Applies To: See VEHICLES AFFECTED

April 30, 2004

Safety Recall: Automatic Transmission Second Gear Inspection
(Supersedes 04-021, dated April 23, 2004)**BACKGROUND**

**AT BEFORE INSTALLATION OF
A/T OIL JET KIT**

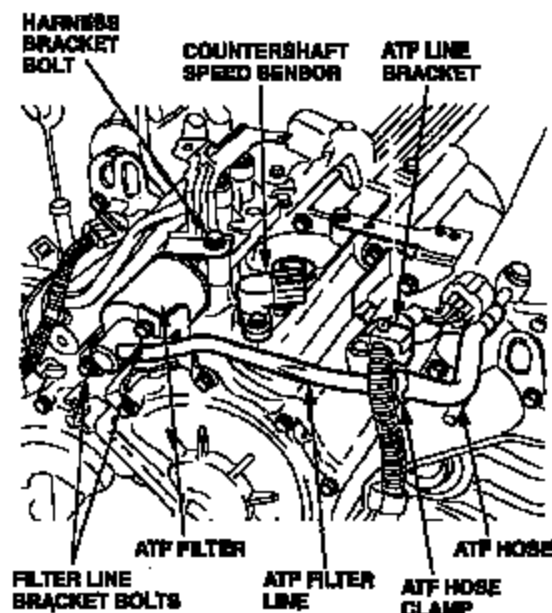
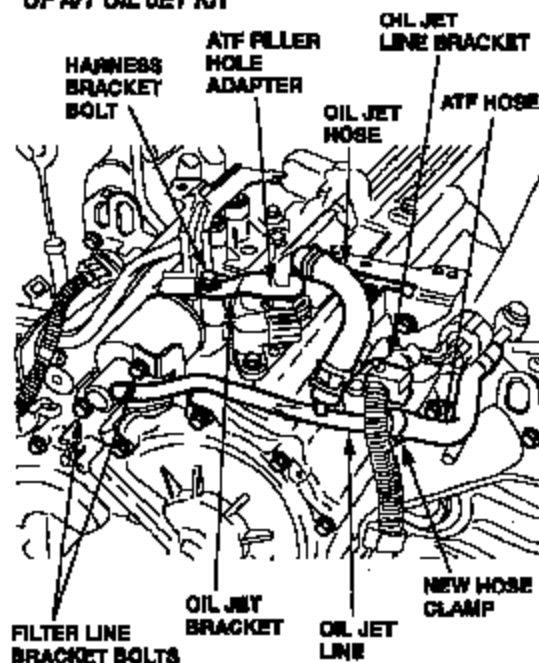
Certain operating conditions can result in heat buildup between the countershaft and secondary shaft second gears in the automatic transmission. Without enough oil flow to dissipate heat, prolonged operation under these conditions can eventually result in decreased material strength. In higher mileage vehicles, this can result in gear tooth chipping or, in very rare cases, gear breakage.

Install an A/T oil jet kit.

9. Install the other end of the oil jet line on the ATF filter, and tighten the filter line bracket bolts to 12 N·m (8.7 lb-ft).
10. Remove the harness bracket bolt.

11. If not already done, remove and discard the ATF filter bolt.
12. Install the ATF filler plug adapter with a new sealing washer, and torque the adapter to 44 N·m (33 lb-ft).

AT BEFORE INSTALLATION OF AT OIL JET KIT

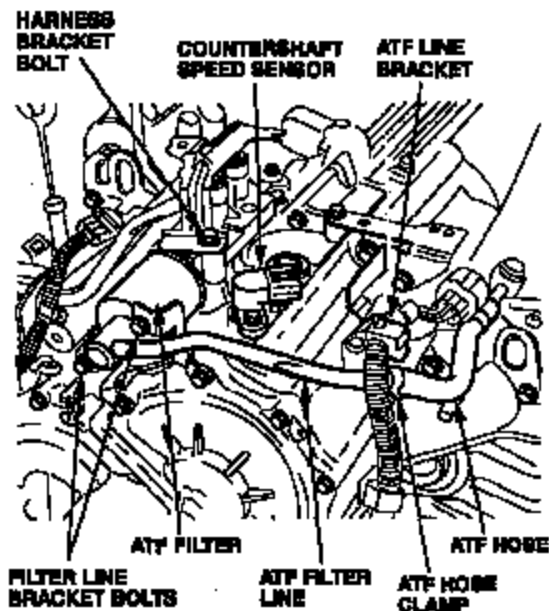
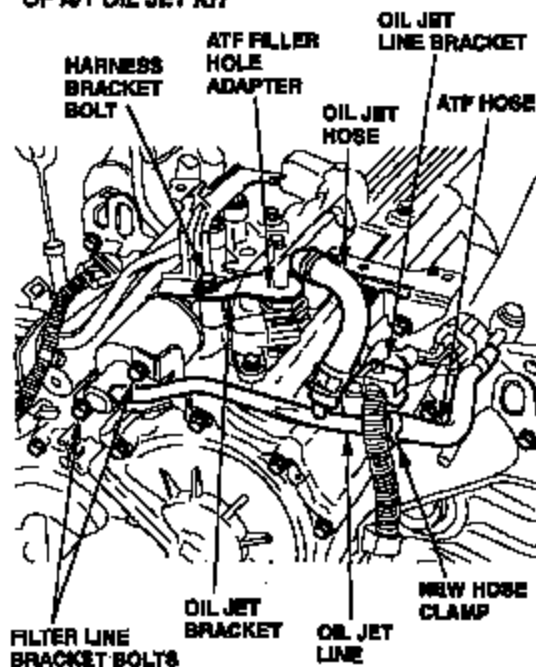
6. Remove the filter line bracket bolts, then remove and discard the ATF filter line assembly.
7. Assemble the AT Oil Jet Kit.

9. Install the other end of the oil jet line on the ATF filter, and tighten the filter line bracket bolts to 12 N.m (8.7 lb-ft).
10. Remove the harness bracket bolt.

11. If not already done, remove and discard the ATF filler bolt.
12. Install the ATF filler plug adapter with a new sealing washer, and torque the adapter to 44 N.m (33 lb-ft).

**AT BEFORE INSTALLATION
OF A/T OIL JET KIT**

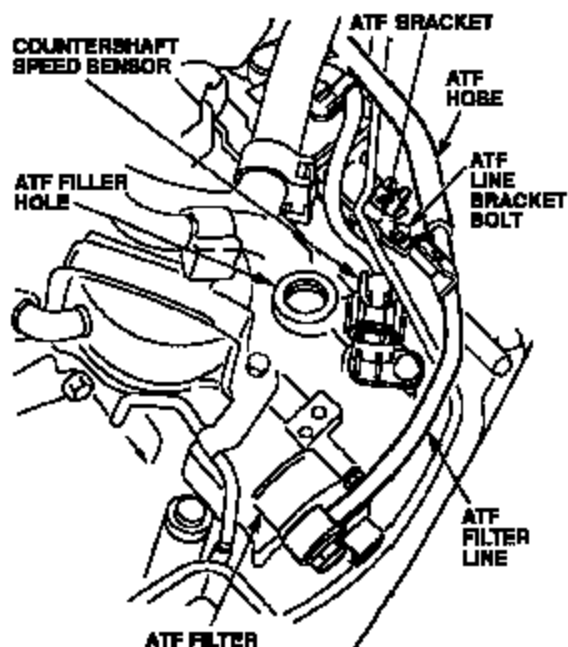
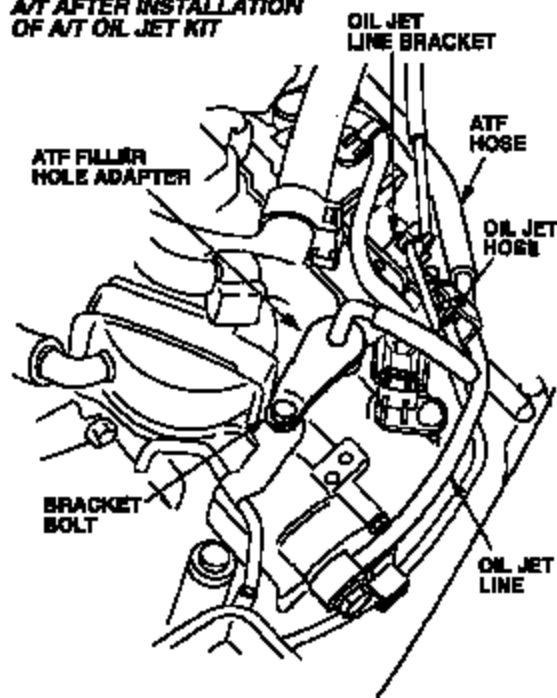
7. Remove the filter line bracket bolt, then remove and discard the ATF filter line assembly.

10. Install the other end of the oil jet line onto the ATF filter, and torque the filter line bolt to 28 N·m (21 lb-ft).
11. Remove the bracket bolt.
12. If not already done, remove and discard the ATF filler bolt.

**A/T BEFORE INSTALLATION
OF A/T OIL JET KIT**

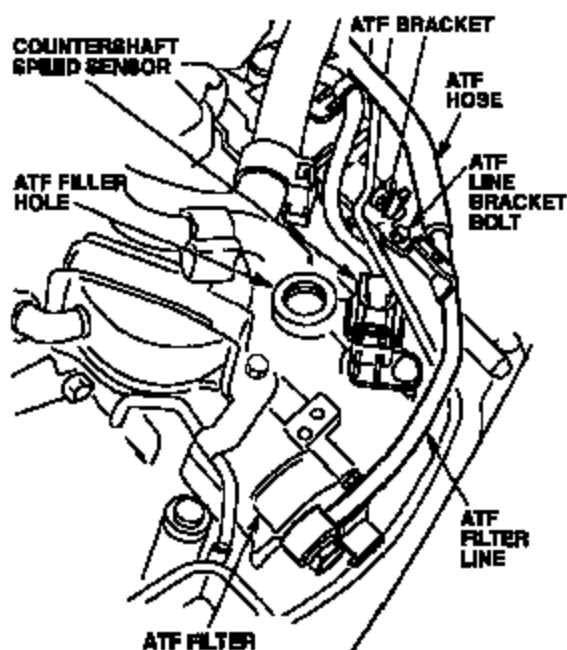
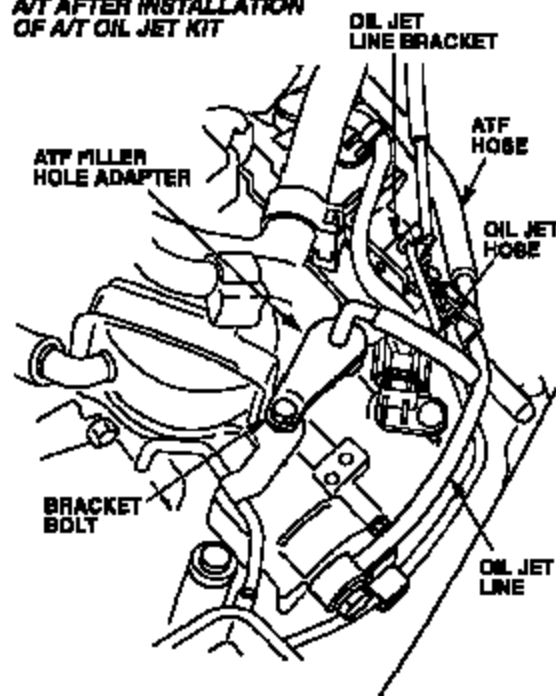
7. Remove the filter line bracket bolt, then remove and discard the ATF filter line assembly.

10. Install the other end of the oil jet line onto the ATF filter, and torque the filter line bolt to 28 N·m (21 lb-ft).
11. Remove the bracket bolt.
12. If not already done, remove and discard the ATF filler bolt.

**3.2 CL and 3.2 TL - A/T BEFORE
INSTALLATION OF A/T OIL JET KIT**

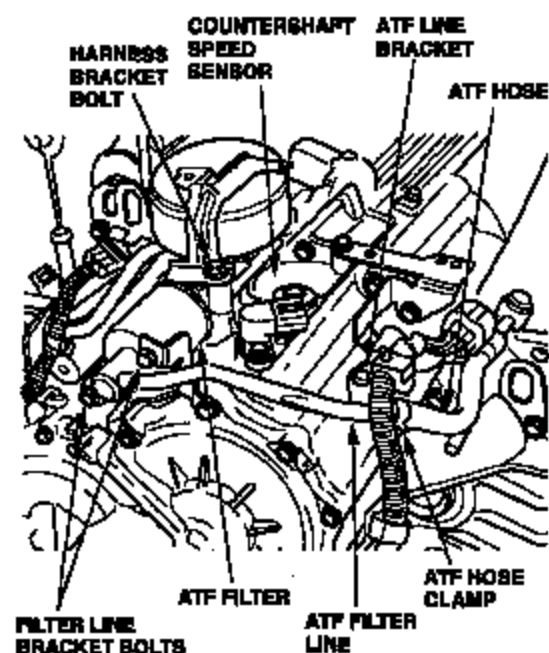
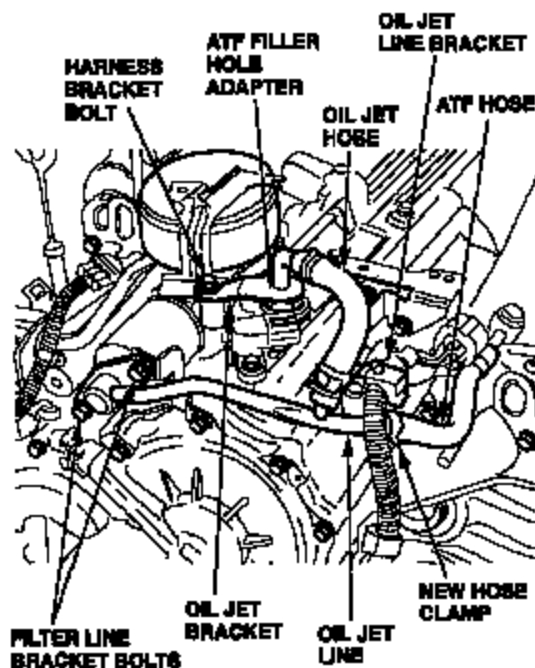
3. Remove the filter line bracket bolt(s), then remove and discard the ATF filter line assembly.

7. Remove the harness bracket bolt.
8. If not already done, remove and discard the ATF filler bolt.
9. Install the ATF filler plug adapter with a new sealing washer, and torque the adapter to 44 N·m (33 lb-ft).
